# Access Compliance Report

## Public Rights-of-Way

### (Curb Ramps)

Intersection ID: 45978	Main Street: NIKKI_COLE_DR	Cross Street: KAYLA_LN	Location: SW
ADA ID: 553BD8AEA1FC	Ramp Type: PerpDiag	Initial Pass/Fail: Fail	Overall Compliance: No
Severity Score: 22.5			
Codes/Mitigation Info/Possible Solution		Field Measurements/Component Compliance

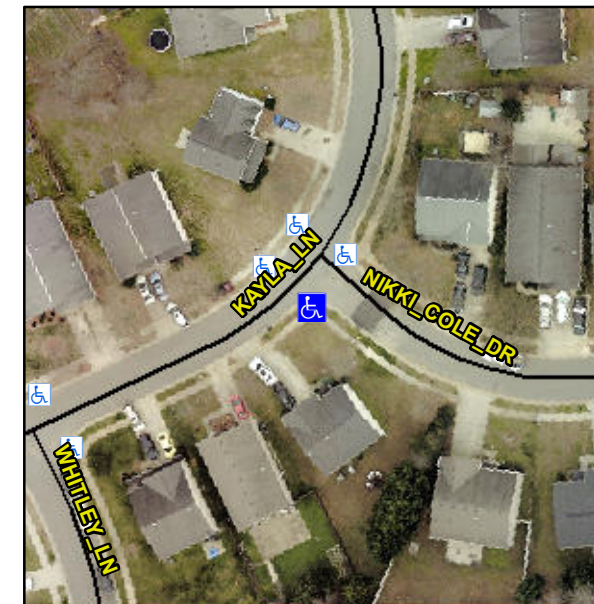
**Not Found, R304.5.1, R304.2.2, R304.5.3**

Compliance	Description	Data	Compliance	Description	Data
N/A	Ramp Length (in)	48.0	No	Ramp Slope (%)	9.8
No	Ramp Width (in)	47.0	No	Ramp XSlope (%)	3.1
N/A	Flare Type LT	N/A	N/A	Flare Type RT	N/A
N/A	Flare Slope LT (%)	N/A	N/A	Flare Slope RT (%)	N/A
N/A	Flare Traversable LT?	N/A	N/A	Flare Traversable RT?	N/A
N/A	Landing Length (in)	N/A	N/A	DWS Provided?	N/A
N/A	Landing Width (in)	N/A	N/A	DWS Contrast?	N/A
N/A	Landing Slope (%)	N/A	N/A	DWS Length (in)	N/A
N/A	Landing X Slope (%)	N/A	N/A	DWS Full Width?	N/A
N/A	Landing Curb? (Y/N)	N/A	N/A	DWS Offset (in)	N/A
N/A	Shared Landing?	N/A			
N/A	Gutter Ponding?	N/A	N/A	Gutter Slope (%)	N/A
N/A	Gutter Lip Ht (in)	N/A	N/A	Gutter X Slope (%)	N/A
N/A	Painted X Walk1?	No	N/A	Painted X Walk2?	No
	X Walk 1 Direction	To NE		X Walk 2 Direction	To NW
N/A	X Walk 1 Width (in)	N/A	N/A	X Walk 2 Width (in)	N/A
	X Walk 1 Slope (%)	4.2		X Walk 2 Slope (%)	4.9
	X Walk 1 X Slope (%)	0.6		X Walk 2 X Slope (%)	3.1

**Remove & Replace Curb Ramp With Two New Directional Ramps or Equivalent.**
